Powerhouse Parramatta Modification 1

St George's Terrace and Eastern Roof Area
State Significant Development Modification Assessment
(SSD-10416 MOD 1)

August 2022

Figure 6 | Proposed eastern building rooftop layout (Source: Architectural plans)

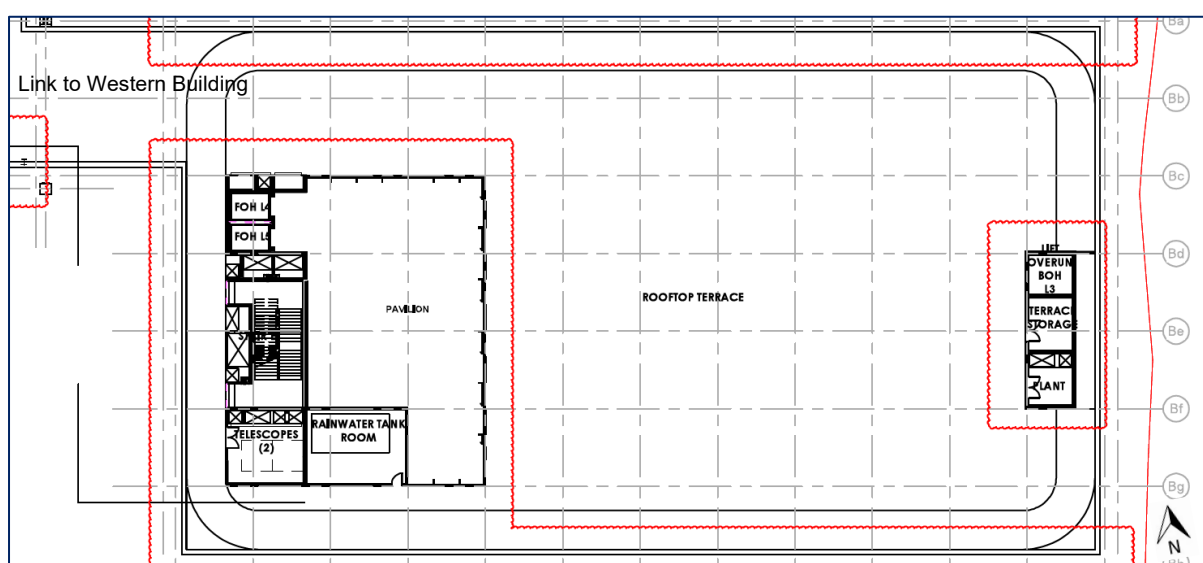
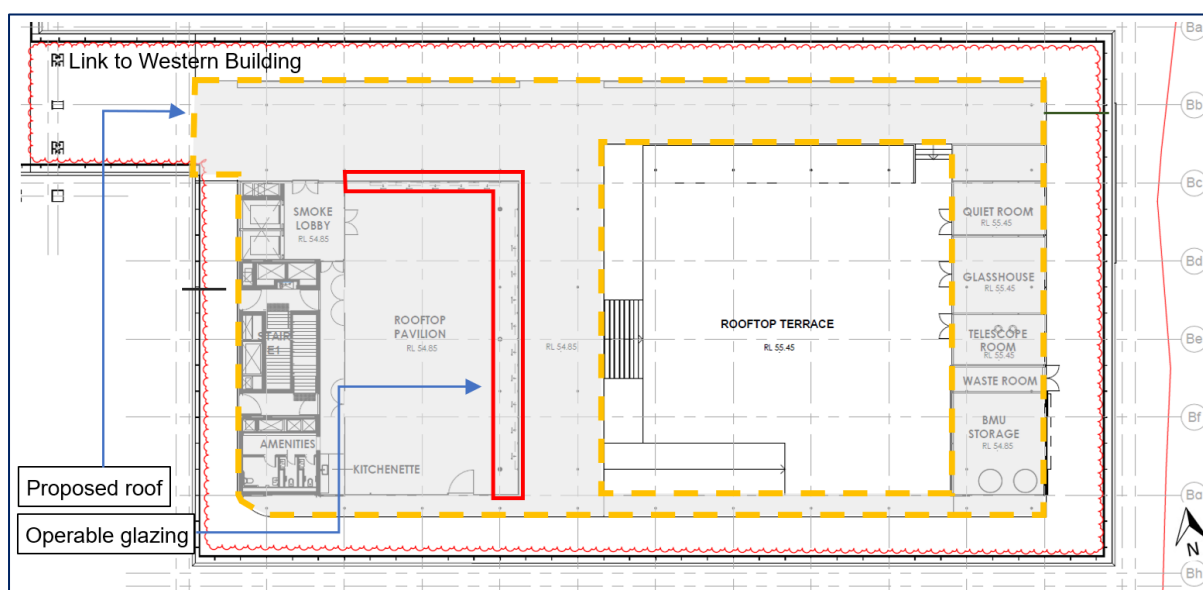
- revise its layout to accommodate new toilets, a kitchenette, relocate a water tank to level 3.2 and provide a new quiet room, glasshouse, enlarged building management and waste and telescope storage on the roofs eastern edge (**Figure 6**)
- construct an expanded pavilion from the service and lift core to the revised storage and building management spaces, with a central cut out for landscaping (**Figure 4**)
- increase the maximum height of the building from RL60.8 m to RL 62.7 m at the top of the revised services core
- increase the GFA of the development by 413 m² to a new total of 24,929 m² (increasing the floor space ratio (FSR) from 1.25:1 to 1.27:1)
- expand the use of the pavilion to cater for a wide range of flexible museum uses.

Council supports the additional event space from the expanded pavilion; but considers the proposal should result in no net landscaping loss.

In response, the Applicant confirmed that while the proposal will reduce soft landscaping by 103 m², the proposed modification will plant an additional eight trees (a total of 30 trees) on the Eastern Building roof. The design will also relocate soft landscaping into planter boxes to support education programs at the site. No changes to the ground level public domain areas are proposed.

The Department has carefully considered the proposed expansion of the Eastern Building rooftop pavilion and supports the changes as:

Figure 10 | Integration options for St George's Terrace and the preferred option 3 in red (Source: RTS)

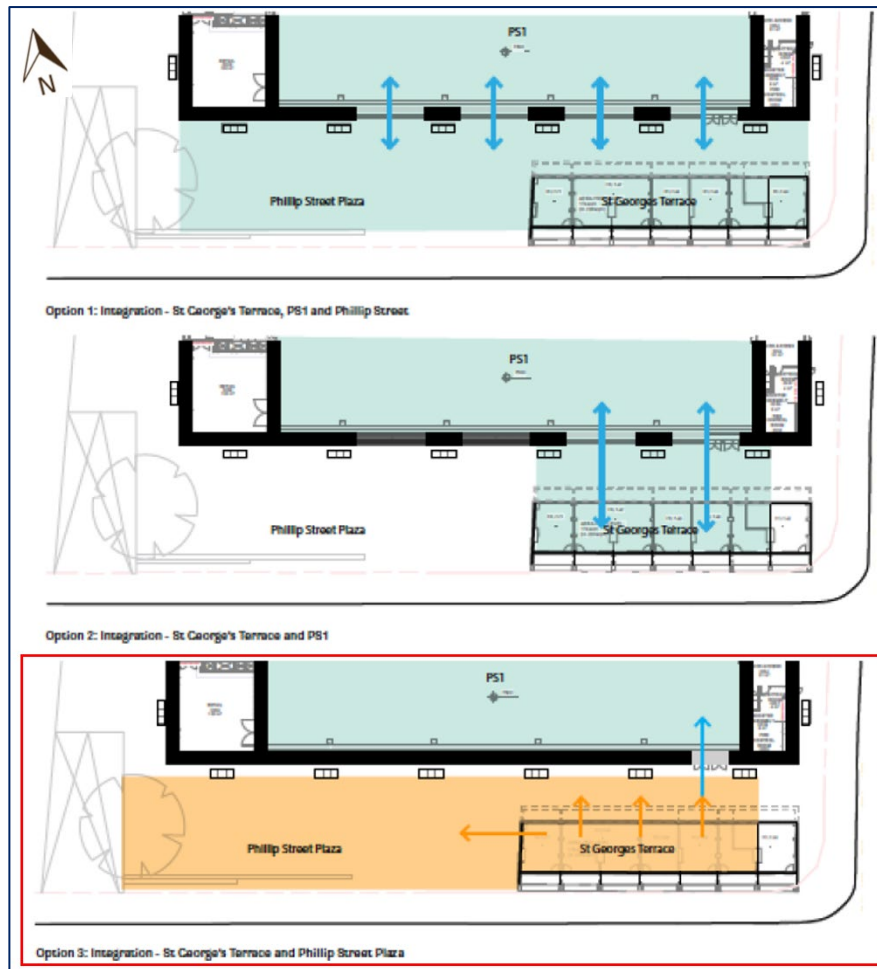
The Applicant presented three design options for the space to demonstrate its connection to Presentation Space 1 and the Phillip Street Plaza as required by Condition C3 (**Figure 10**). The Applicant considers the integration of St George's Terrace is not predicated on a physical connection. Rather, reliance is placed on the ground plane to create a link between the spaces.

The Applicant considers Option 3 (**Figure 10** - outlined in red), maintaining the solid walls of Presentation Space 1, construction of one set of double doors from Presentation Space 1 to the St George's Terrace laneway and three sets of double doors along the northern elevation of St George's Terrace (**Figure 11**) is the most appropriate design as it:

Notwithstanding, the Department on balance is satisfied that the proposed design, and use of St George's Terrace integrates and activates the space between St George's Terrace, Presentation Space 1 and Phillip Street, and meets the intent of Condition C3 as:

Figure 11 | Northern elevation of St George's Terrace (left) and western laneway elevation (right) (Source: Architectural Plans)

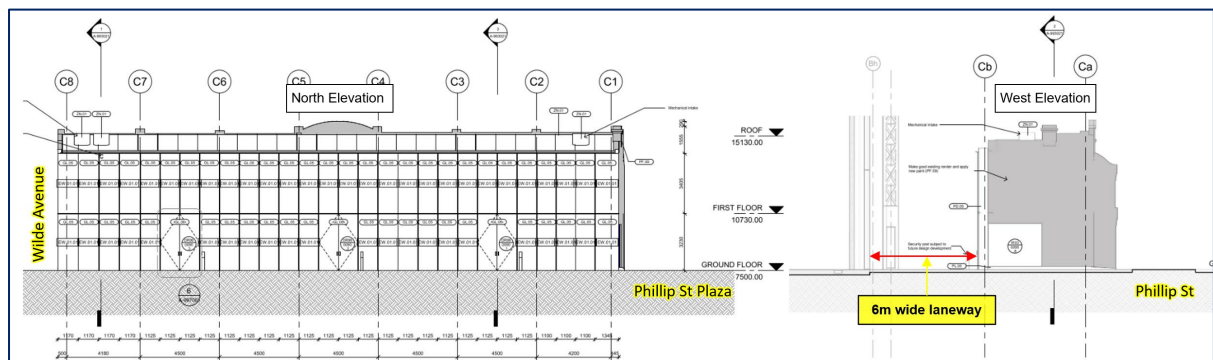
The DIP also considers any design changes to Presentation Space 1 will significantly compromise future museum operations and is satisfied that the proposed design changes to St George's Terrace meets the objectives of integration with the broader Powerhouse Parramatta precinct as:

Figure 12 | South elevation of St George's Terrace and elements to be retained and removed
(Source: DPE)

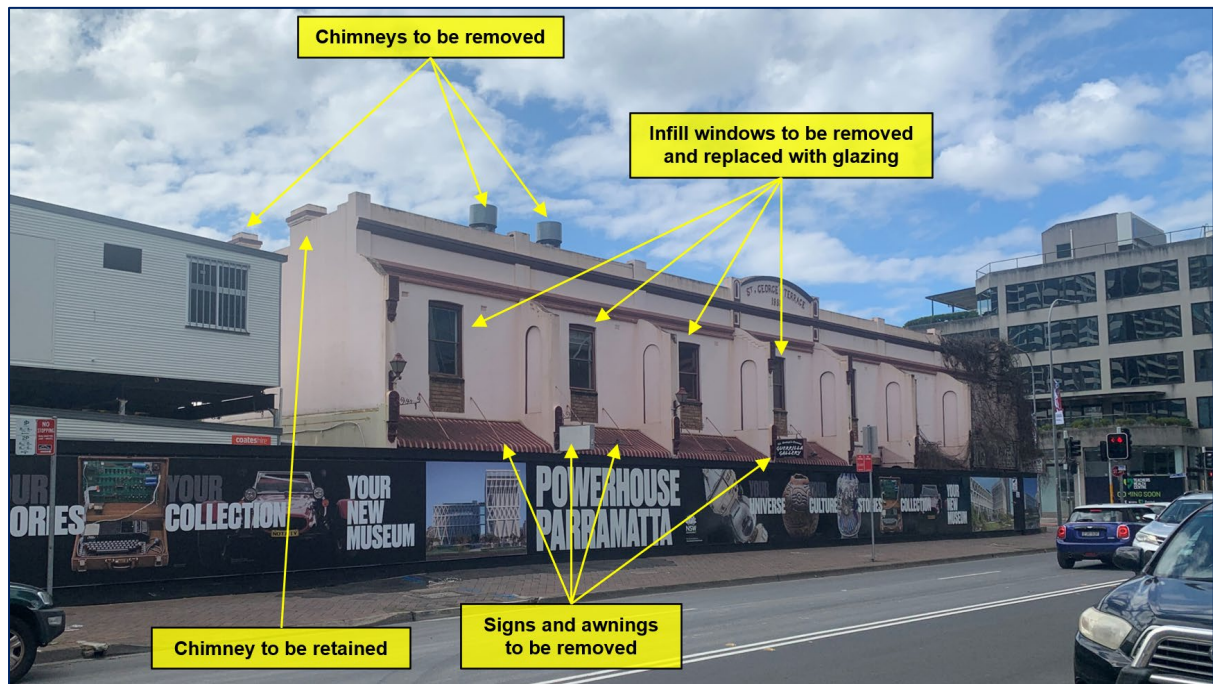
Council raised concerns about the proposed works to St George's Terrace and requested the original proportions of windows, doors, ground and first floor verandahs, awnings and colour scheme be reinstated.

Following the RtS, Council suggested alternative solutions to interpret party walls, chimneys, first floor verandahs and pavement at ground level. This includes reinstating the former residential first floor verandahs from the proposed internal stairwell and providing maintenance access by removing brickwork in the arched outcrops to create a connected area.

In response, the Applicant revised the scope of conservation works to include reinstating the original proportion of windows and doors, restoration of plaster urns, original colour palette and interpretation of ground floor verandahs. However, the Applicant maintains that retaining chimneys in the proposed double height space is not structurally feasible and that it is not appropriate to reconstruct the first floor verandahs as:

The Department has carefully considered the advice provided by Council and acknowledges the desire to maximise conservation and reinstatement of the significant elements of the building including chimneys, internal walls, ground and first floor verandahs. The Department has balanced this against the objectives for the proposal to integrate with and support the function and design of the Powerhouse Parramatta development and also achieve heritage best practice. On balance, the Department is satisfied the proposal will result in a positive heritage outcome as:

The Department recommends new condition C16A to require details for interpretative elements for chimneys, fire places and party walls (which may include inlays), ground floor verandahs and details of an interpretive element of the first floor verandahs in St George's Terrace to be prepared in consultation with Council, to the satisfaction of the Secretary before the commencement of works to St George's Terrace, except for demolition works proposed by this application.
